Subj: Sheriff Patrol Headquarters- Approve of Change Order #1

RE Scott County Sheriff's Patrol Headquarters

COR 1

T&M over excavation of unsuitable soils & replacement with unit priced granular fill

Sketch of Area Inspected - 5/19/16

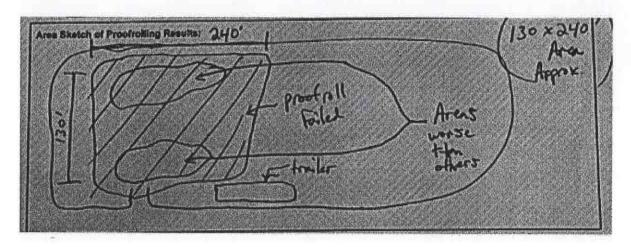
The May 19, 2016 inspection was performed on the south half of the property. It was observed that the upper 12 to 18 inches of surface soils in a 130 foot by 240 foot area were soft and saturated due to surface water and/or groundwater. Rutting of 3 to 12 inches was noted during proofrolling in these areas. Therefore, we recommend that the softened soils should be removed and replaced with engineered compacted and tested fill meeting the project specifications. If water seepage is encountered during overexcavation, clean crushed rock may be required for the first lift of fill to provide a stable base for placement and compaction of additional fill. Additional crushed rock, possibly up to 18 inches, may be required in areas where heavy construction traffic is anticipated. Further, depending on the amount of construction traffic on the crushed rock following placement, a geotextile fabric may be required to prevent migration of the silty soils into the clean granular materials.
